12. RESPONSE TO NRC QUESTIONS

Given below are NRC questions concerning the Licensing Report on High-Density Spent Fuel Racks for Quad Cities Units 1 and 2. They are listed by date of transmittal. Also given below are responses to those questions or the word "Later" indicating that the response will be communicated at a later date.

FIGURE 3-7 -- SPENT FUEL RACK UPLIFTING CRADLE

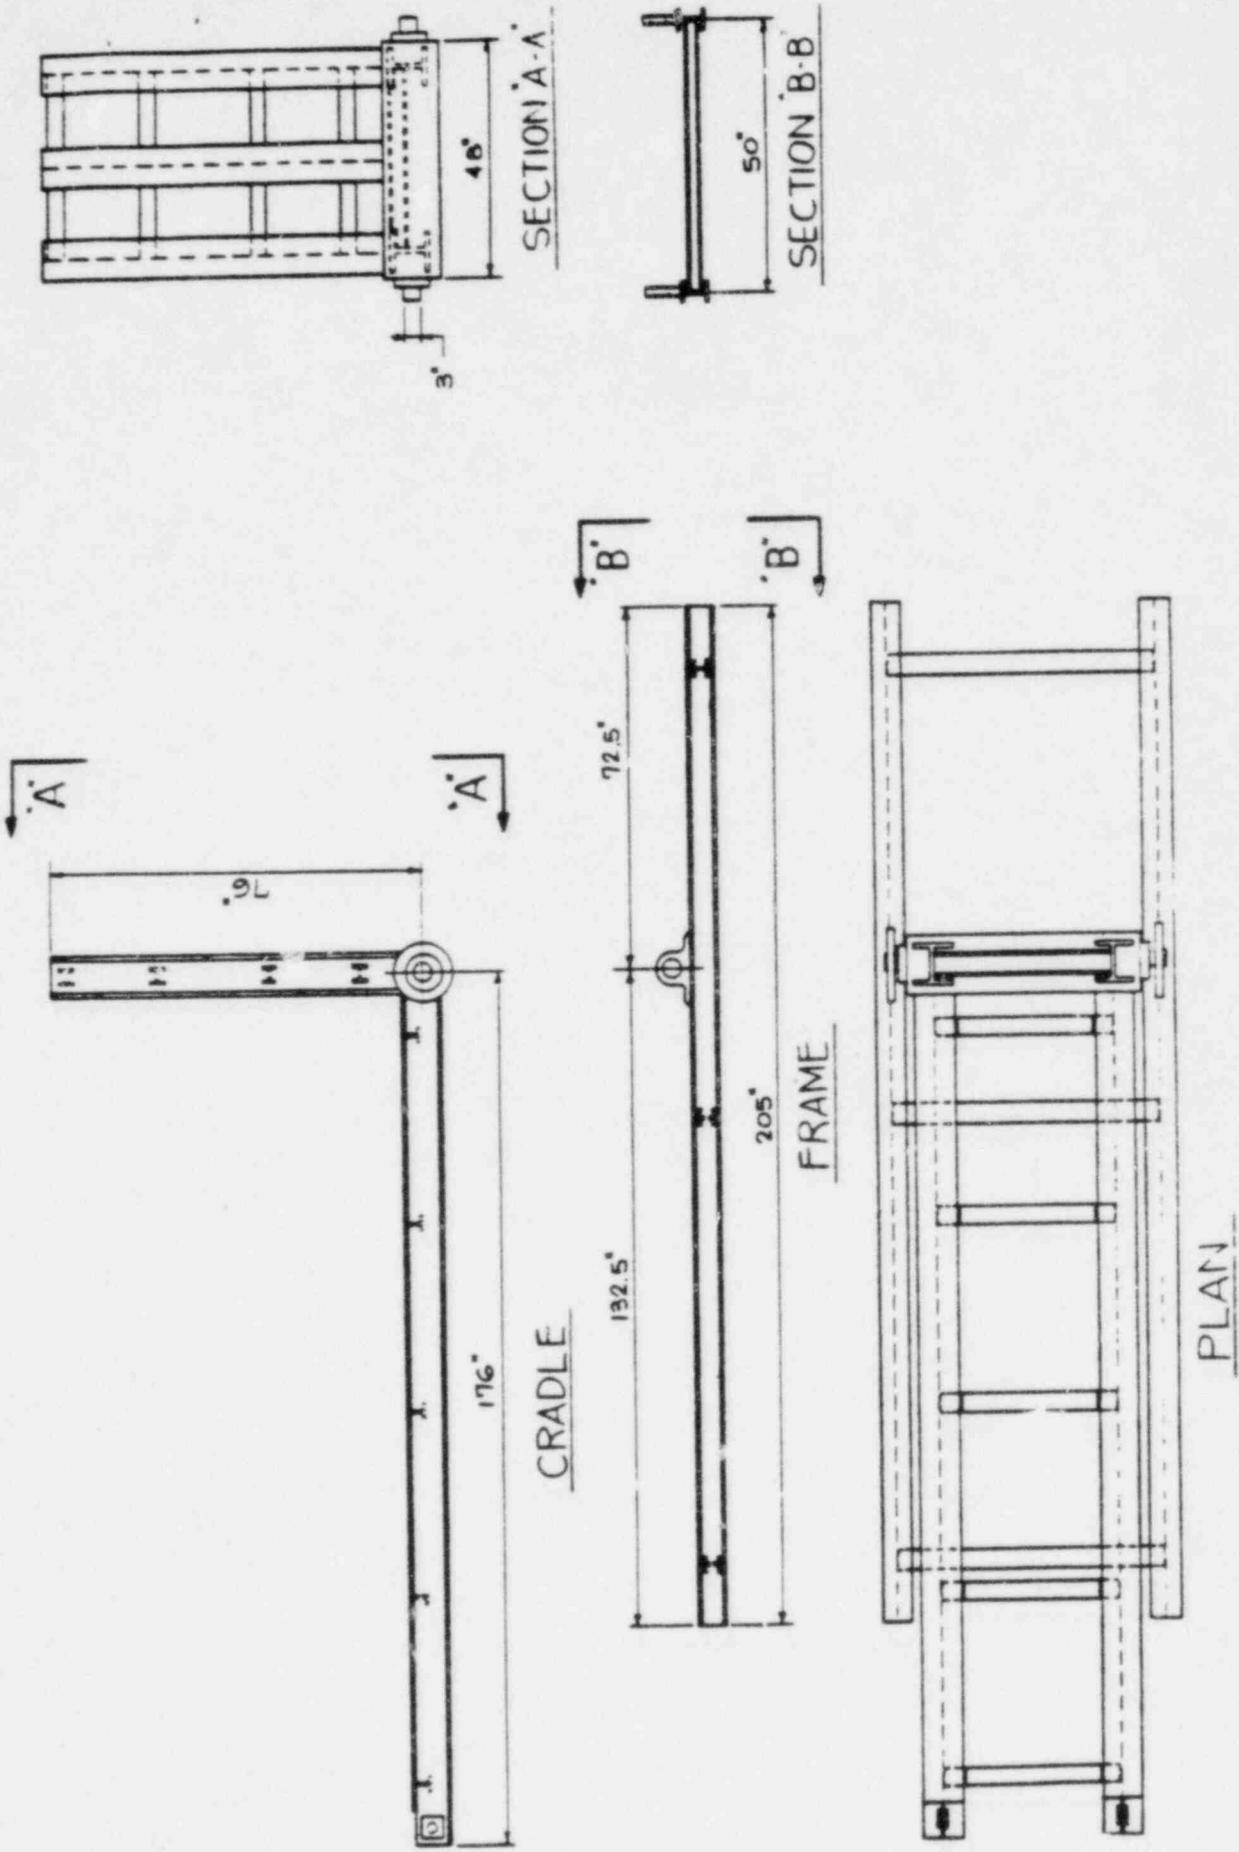
- h. Using Figure 3.7, describe and discuss the ability of the high density storage racks to protect the stored spent fuel assemblies from damage following a load drop.

Response: Two fuel assembly drop conditions are described in Section 6.6. Accident I, where the fuel assembly is postulated to drop and impact the base plate, the maximum deformation of the plate is approximately 0.5". It is proved that the base plate is not pierced. The analysis is based on a very conservative model which ignores the fluid drag of water in the cells, and does not account for material strain hardening.

Accident Condition II postulates that the fuel assembly drops on top of the rack and impacts at its weakest location. Maximum local stress in the region of impact is 22900 psi which is below the material yield point.

FIGURE 3-8 - SPENT FUEL RACK LIFTING FRAME ASSEMBLY

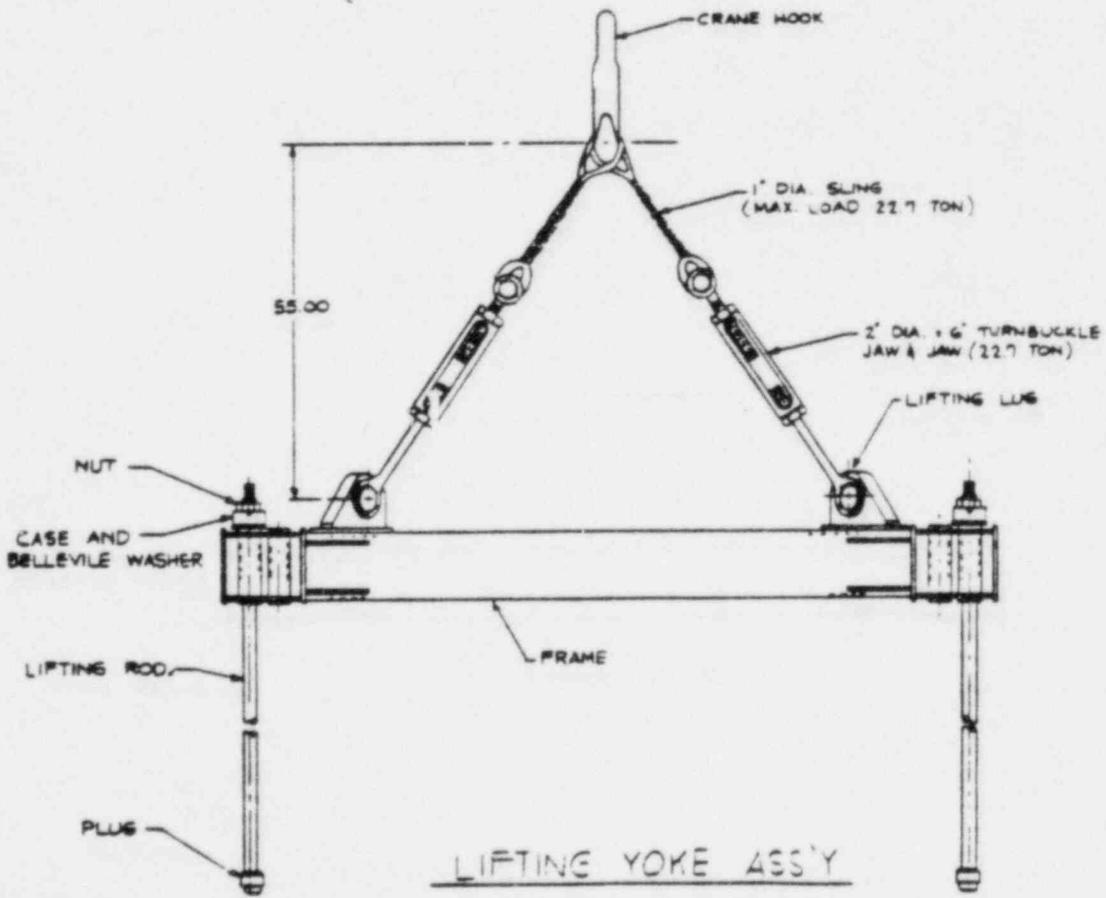
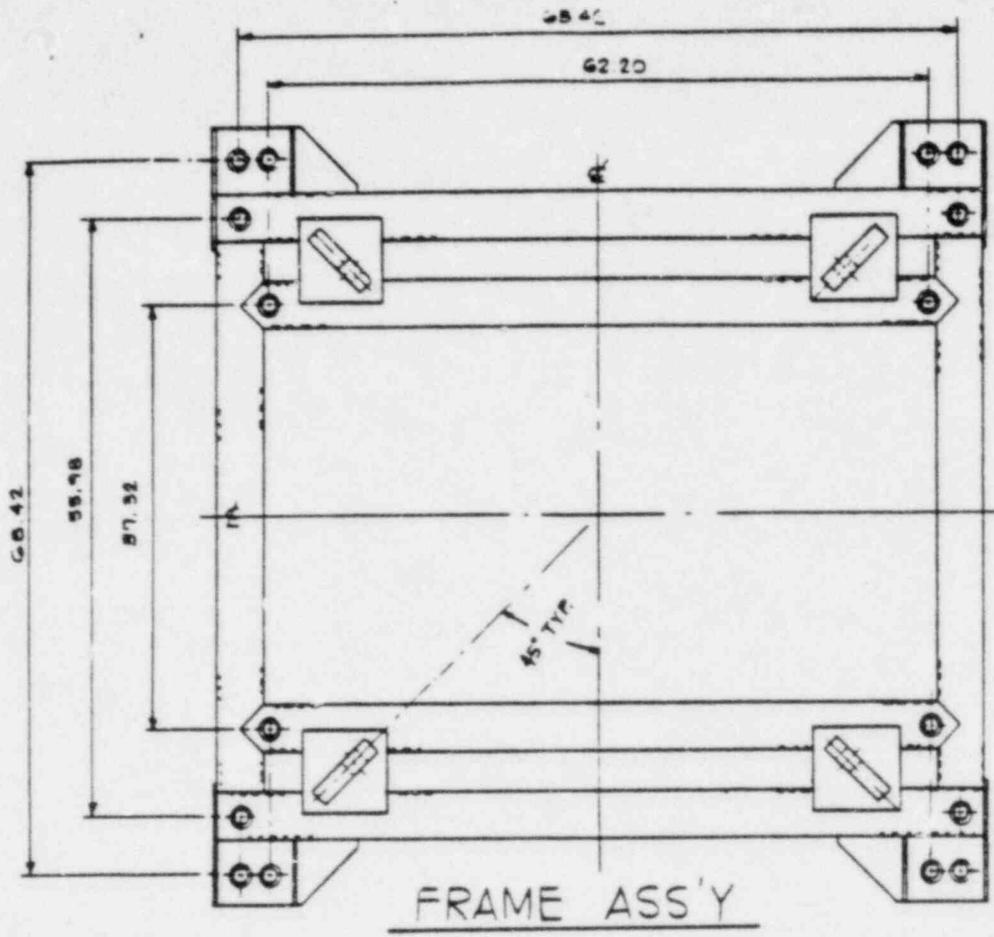
- b. Provide the weights of the racks. Describe and demonstrate the adequacy of the lifting rig attachment points, on the new and old racks, to withstand the maximum forces that will be experienced during the load handling operations.

- c. With the aid of a drawing, describe the lifting rigs that will be employed in handling the racks and demonstrate their adequacy.

Response: The weight of the racks is contained in the Revision 1 Licensing Report submitted to the NRC on June 24, 1981 by letter from T. J. Rausch to G. R. Denton. Lifting rig requirements are not yet defined and will be submitted later.

Response: Later
